Design Review Board Staff Report

SUBJECT: DR14-25, POPEYES LOUISIANA KITCHEN

DR14-25, Popeyes Louisiana Kitchen: site plan, landscape, grading and drainage, elevations, floor plans, lighting, colors and materials for approximately 0.98 acres located at the southeast corner of Market Street and Pecos Roads zoned Regional Commercial (RC) with a Planned Area Development (PAD) overlay.

DR14-25: Popeyes Louisiana Kitchen
Exhibit 5 - Landscape

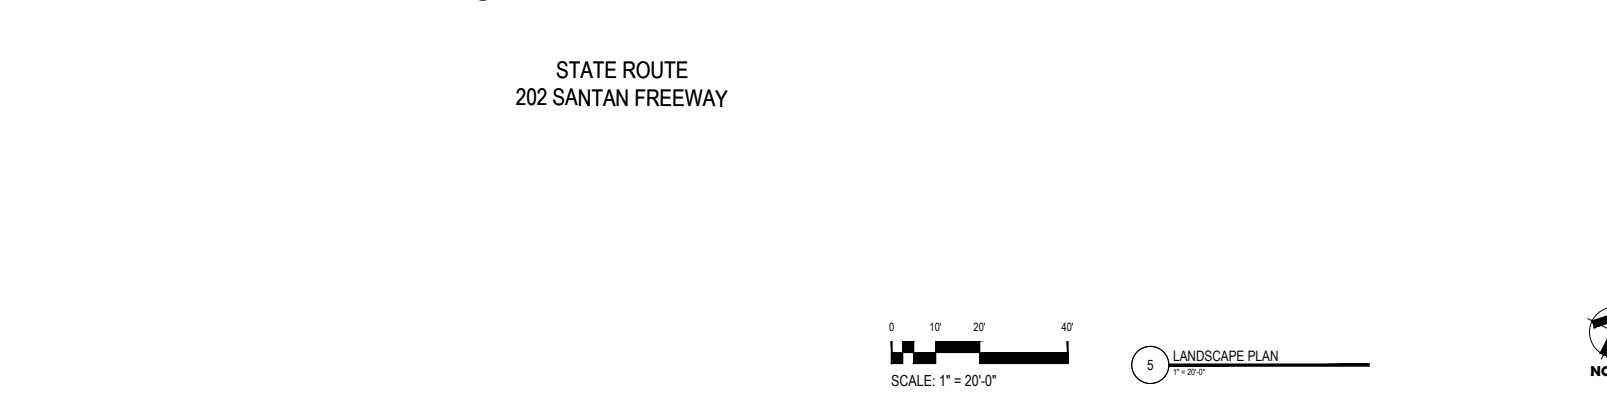
Study Session: Staff commented that outdoor seating with decorative hardscape and shade control should be provided on the north side of the building. The applicant added outdoor amenity area with seating. Staff also commented that foundation planting would be required around the building on all four sides. The applicant added foundation planting. Lastly, staff commented that the parking island will be required to have a groundcover beneath the trees. A more detailed landscape plan will be required. The applicant provided a more detailed landscape plan for the pad improvements.

DR14-25: Popeyes Louisiana Kitchen
Exhibit 7 - Elevations

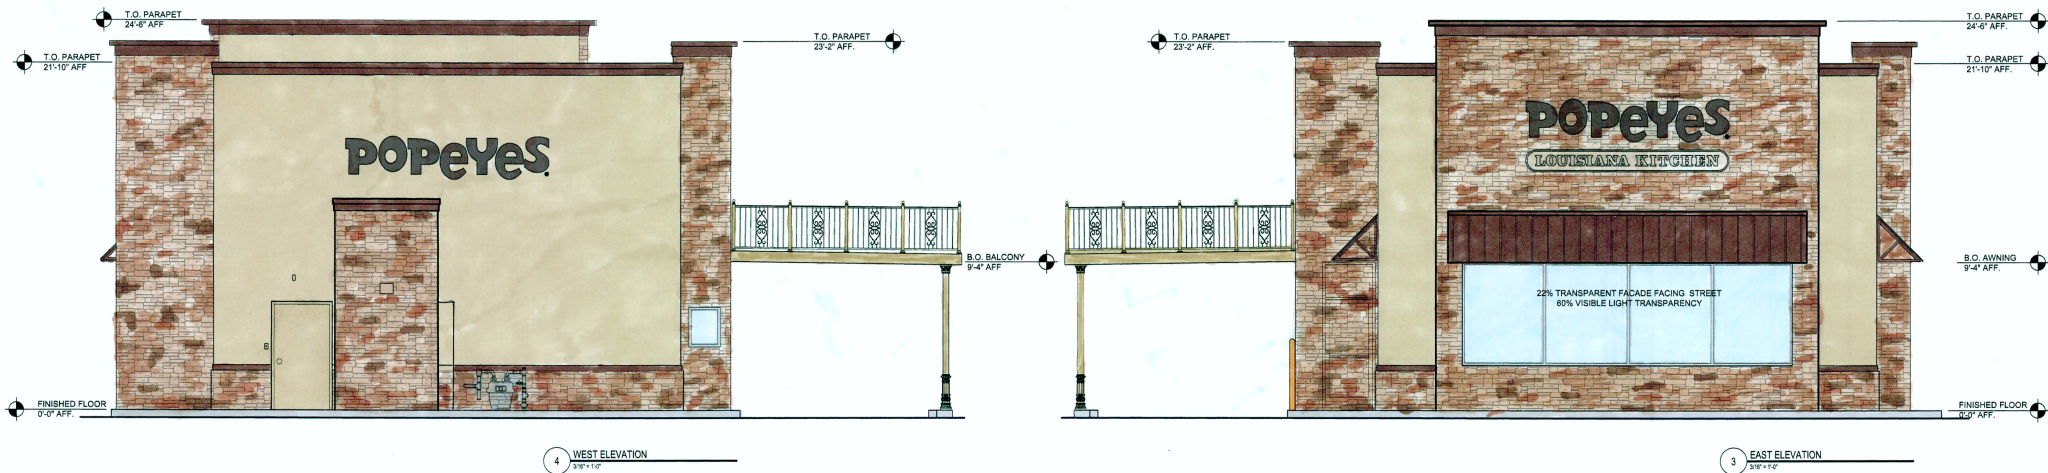
Board members recommended the stone height be lowered and that the roof access ladder and rain gutters should be internalized. The applicant revised the stone massing and height, and internalized the roof access and downspouts.

Board members also noted that the rear elevation shown was unfinished and that the shutters were oversized and out of scale. The applicant has agreed to finish the rear parapet walls and has revised the elevations, resized the shutters and moved them down on the wall mass.
